GOVERNMENT OF THE DISTRICT OF COLUMBIA **DEPARTMENT OF TRANSPORTATION**

MEMORANDUM

ZC Case No. 17-05 - 2100 2nd Street SW

Figure 5 Existing Pedestrian Network Conditions (Source: the Applicant)

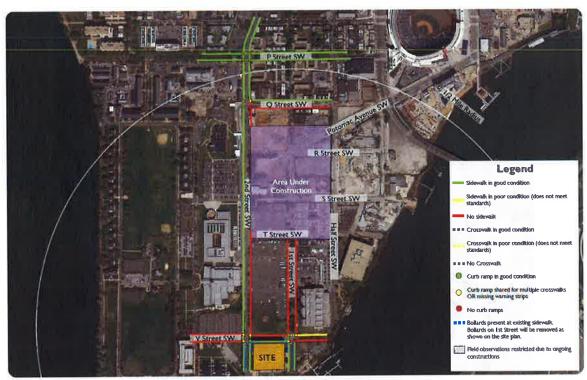
The Applicant performed an inventory of the pedestrian infrastructure in the vicinity and noted any substandard conditions (Figure 3). The Applicant's analysis revealed substandard pedestrian facilities in the vicinity of the site, such as missing sidewalks along the route to the Navy Yard and Southwest Waterfront Metro stations. Many of these gaps will be improved by the subject development and adjacent developments including ZC Case Nos. 16-02, 16-06, and 10-21A. However, some gaps are expected to remain, namely on the west side of 1st Street and the east side of 2nd Street between T Street and V Street, which provides access to the 100 V Street surface parking lot, and on the north and south sides of V Street west of 2nd Street, which provides access to the James Creek Marina surface parking lot. Without pedestrian improvements to these segments, these likely satellite parking locations will be inaccessible by pedestrians.
